R2301: PACCAR MX Engine Model Year 2022 Pre-Production Retrofit

3/24/2023

The emissions exemption **expired on 12/31/2021** for certain pre-production vehicles equipped with PACCAR Model Year 2022 MX engines. Production-level engine, VECU, and Digital Display software is now available to make these vehicles compliant. New Engine Emissions and Clean Idle labels will be installed.

Engine Emissions label placement:

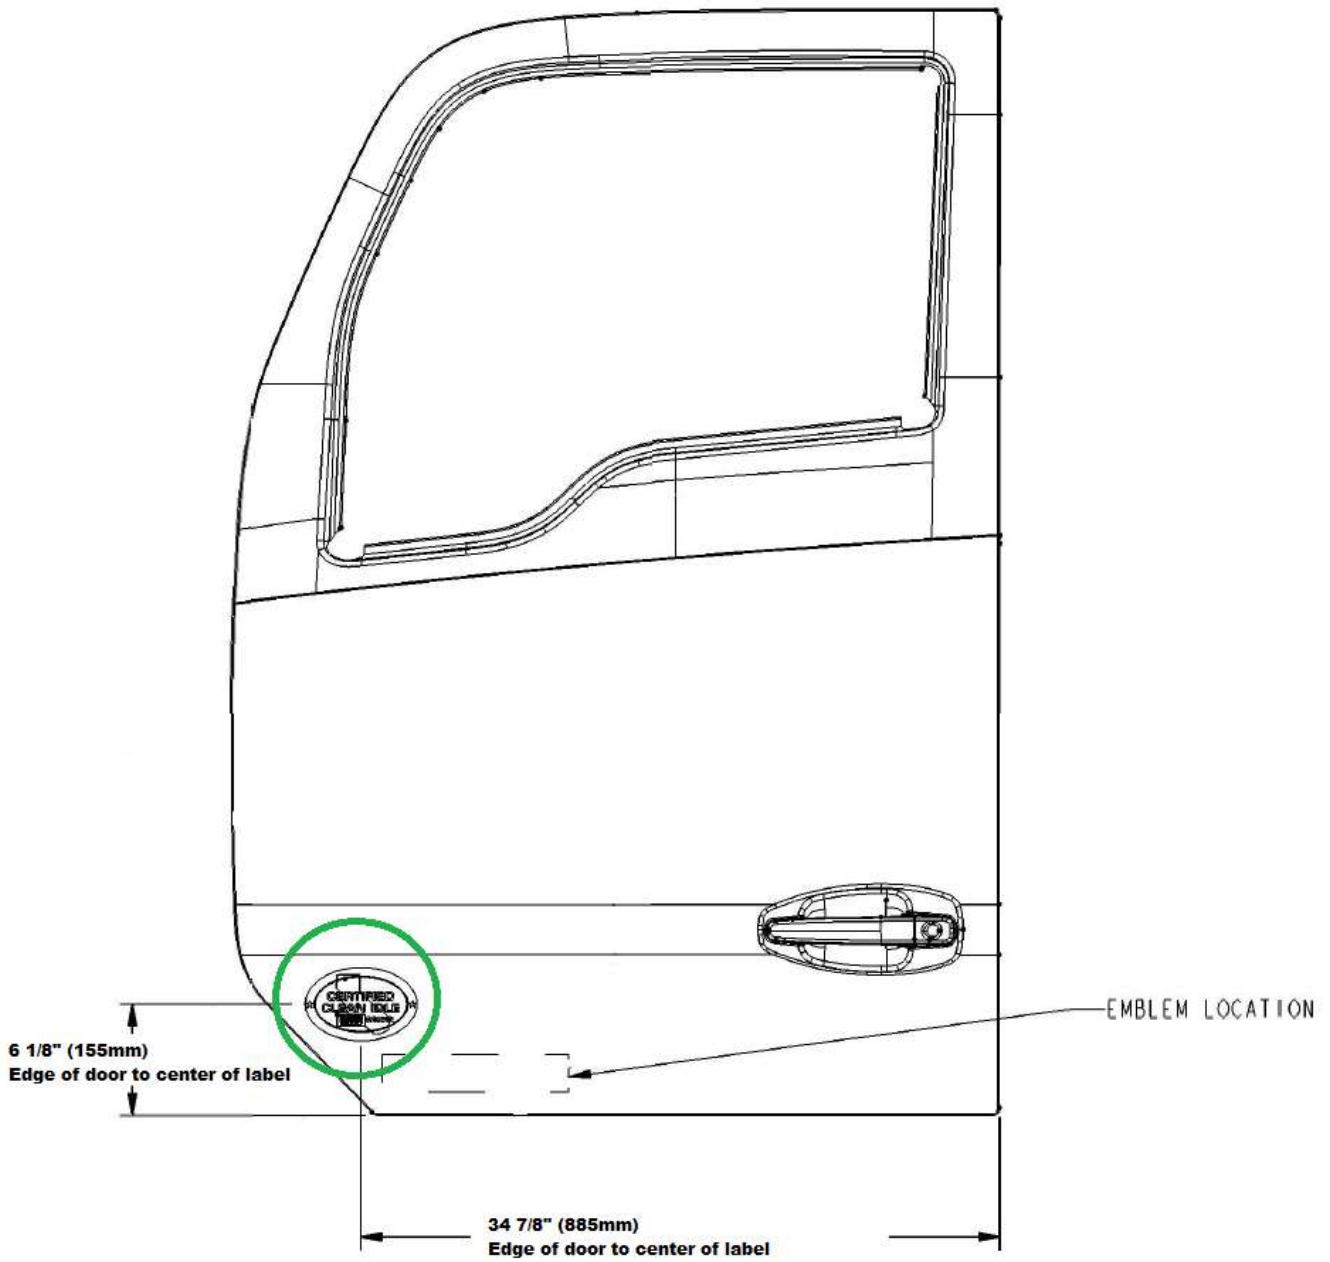
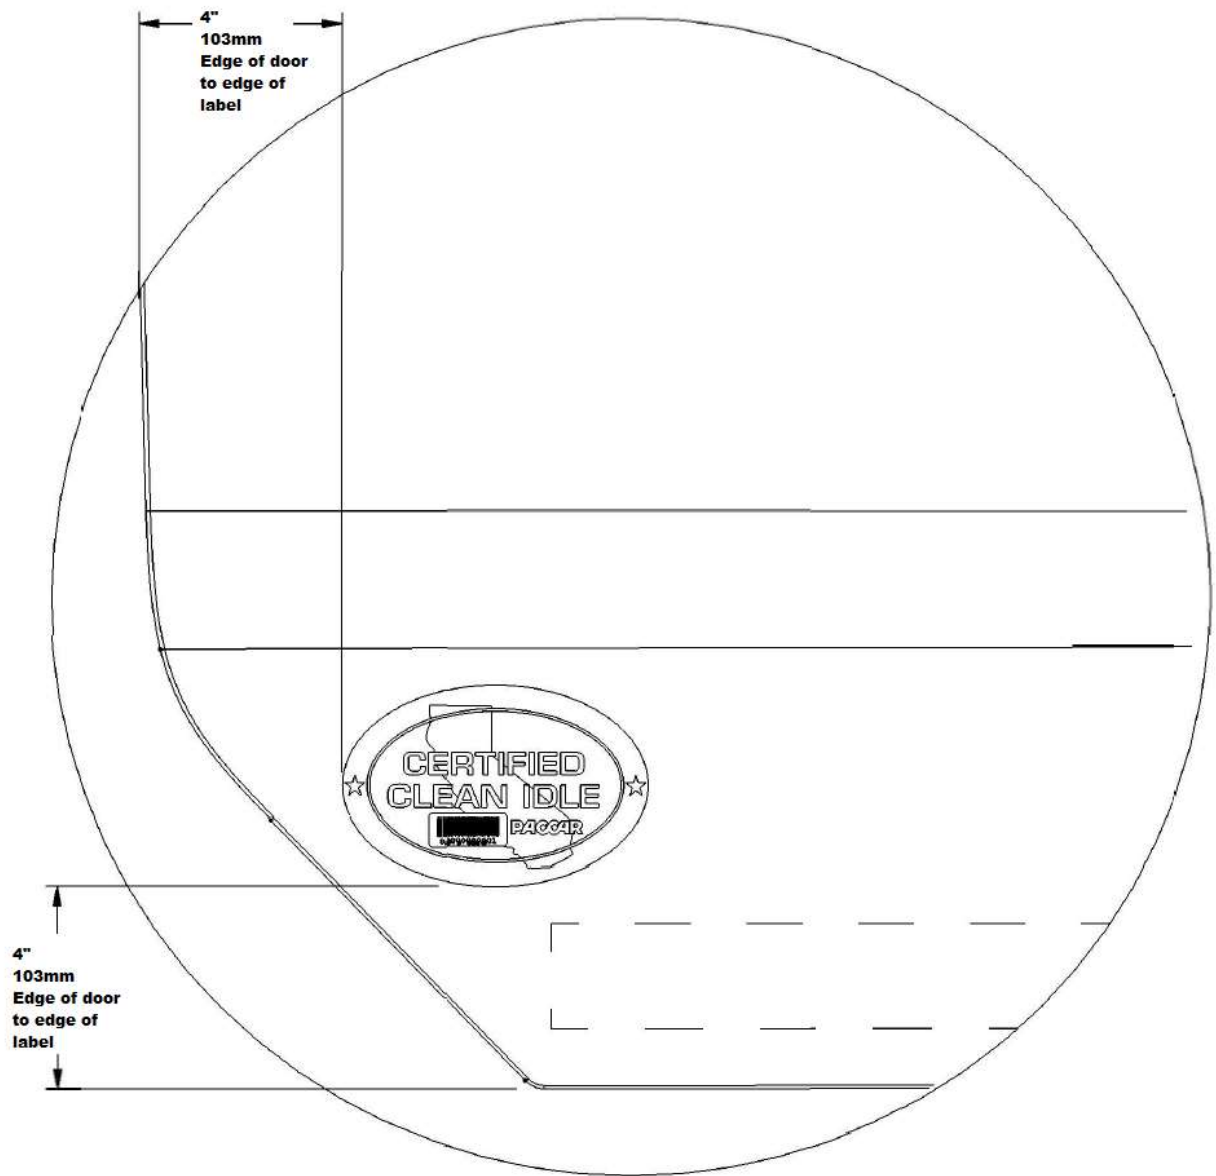
8. Apply the Engine Emissions Information label to the engine air horn and the Clean Idle label to the driver's door of the vehicle as shown below.
